**COUNTY OF SAN MATEO
PLANNING AND BUILDING DEPARTMENT**

SUBJECT: Consideration of a Design Review (DR) Permit and Coastal Development Permit (CDP) pursuant to Sections 6565.3 and 6328.4, respectively, of the San Mateo County Zoning Regulations, to allow for a 322 sq. ft. first-floor addition, 290 sq. ft. second-floor addition, demolition and reconstruction of a new 400 sq. ft. rear deck, and interior remodel of an existing 975 sq. ft., two-story, single-family residence with an attached 464 sq. ft. two-car garage, on a developed 7,696 sq. ft. parcel. The project site is located at 400 Vermont Avenue in the unincorporated Moss Beach area of San Mateo County. The project includes minor grading and no tree removal. The project is exempt from environmental review, pursuant to the California Environmental Quality Act (CEQA) Guidelines Section 15301(e) (Class 1, Existing Facilities). The project is appealable to the California Coastal Commission.

County File Number: PLN2025-00034 (Bodas Construction, Inc.)

Elevation 15 - Current

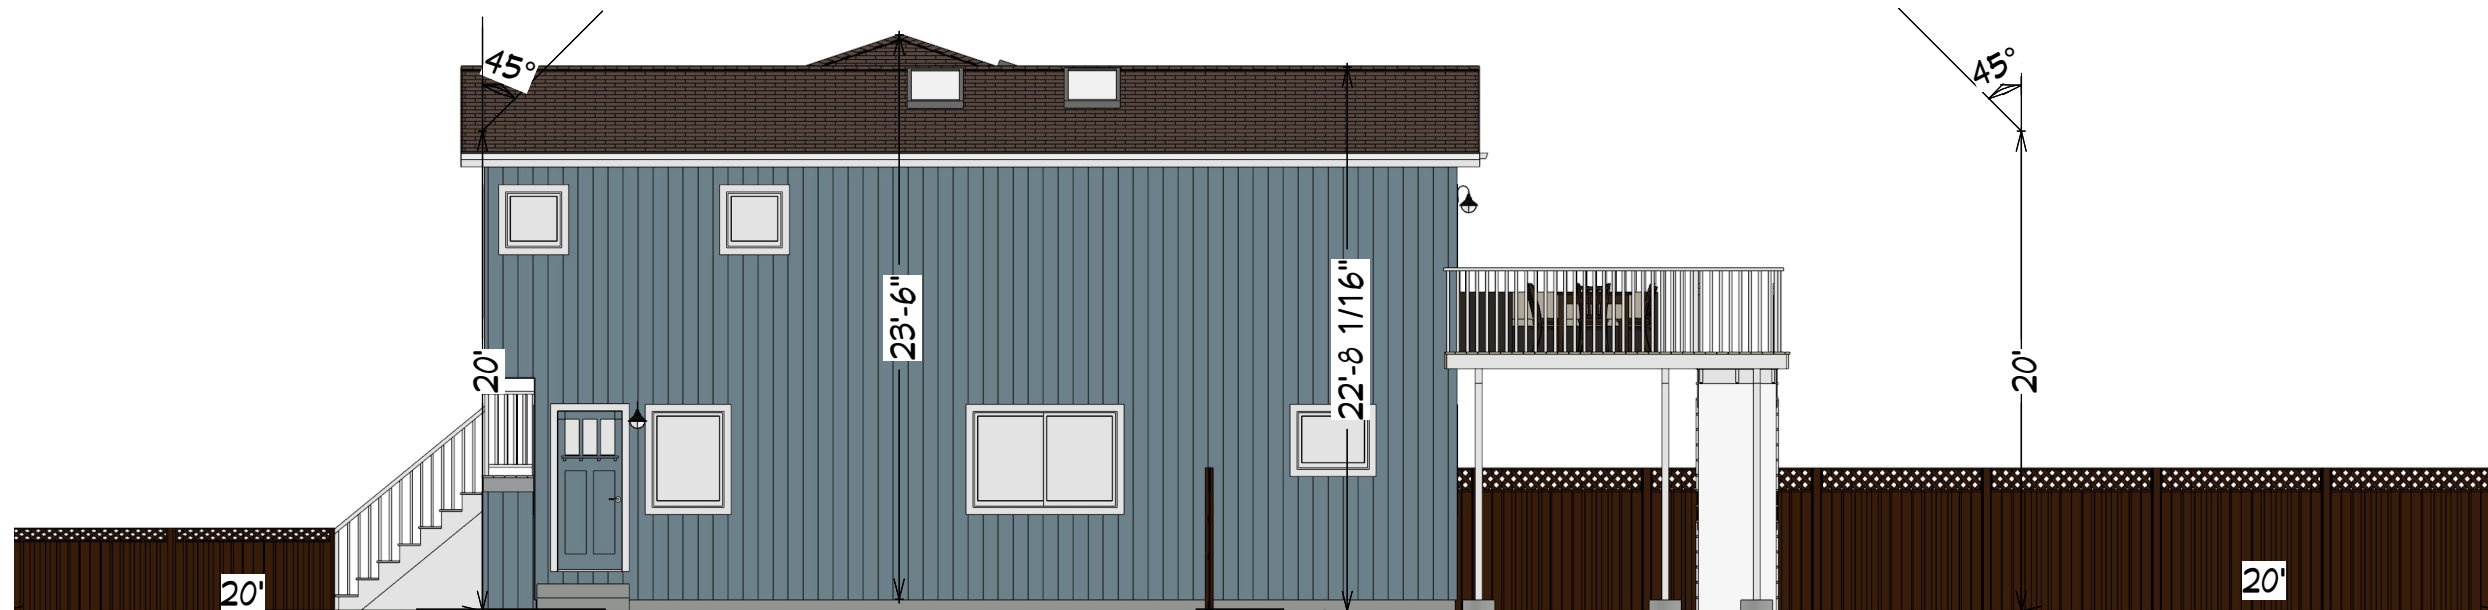
- (1) The addition façade (shown on Sheet A14 – Elevation 15) lacks sufficient articulation. To address this, incorporate a two-story trellis along the addition, which will help break up the massing and enhance visual interest.
- (2) The white fascia on the new deck creates a bulkier appearance compared to the existing deck. To reduce the perceived massing, the deck fascia shall be painted or stained a darker brown.

- 12. The addition façade (shown on Sheet A14 – Elevation 15) lacks sufficient articulation. To address this, incorporate a two-story trellis along the addition, which will help break up the massing and enhance visual interest.
- 13. The white fascia on the new deck creates a bulkier appearance compared to the existing deck. To reduce the perceived massing, the deck fascia shall be painted or stained a darker brown.
